**SUNDRY NOTICES AND REPORTS ON WELLS**  
*Do not use this form for proposals to drill or to re-enter an abandoned well Use form 3160-3 (APD) for such proposals.*

Well Name COTTON DRAW UNIT 162H		Field COTTON DRAW CENTRAL	
Location 330' FSL & 860' FWL SEC 11-T25S-R31E		County EDDY	State NM
Elevation 3270 KB 3245' GL 25' KB to GL		Spud Date 11/15/12	Compl Date 2/6/13
API# 30-015-39730	Prepared by Ronnie Slack	Date 3/27/18	Rev

**PROPOSED P&A WELLBORE**

**Permanent Abandonment of Federal Wells**  
**Conditions of Approval (LPC Habitat)**

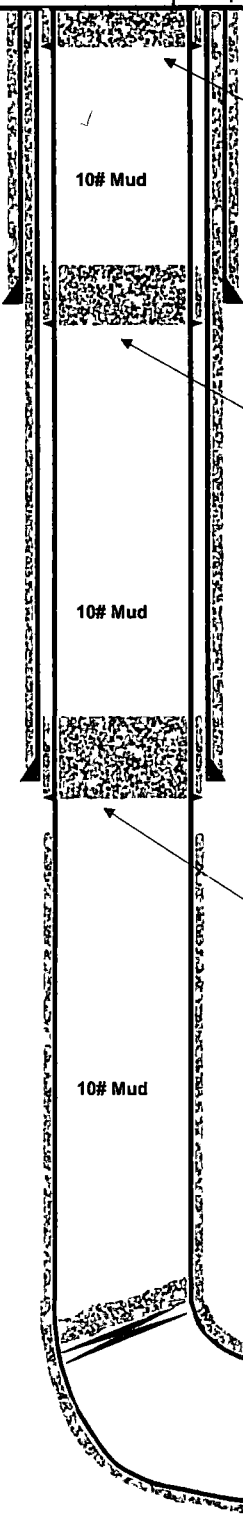
**\*\* BLM REVISED \*\* BLM REVISED \*\* BLM REVISED \*\* BLM REVISED \*\* BLM REVISED \*\***

**Proposed**  
 2 Pmp 90 sx (300) CI C in/out @ 1 000 700 Tag  
 1 Perf @ 1 000'  
 (3000 spacer 996 T Salt 919)

**Proposed**  
 2 Pmp 195 sx (664) CI C in/out @ 4,660' 3,996' Tag  
 1 Perf @ 4,660  
 (3000 spacer 4660 T Delaware 4339 B Salt 4119)

*Below ground level dry hole marker required*
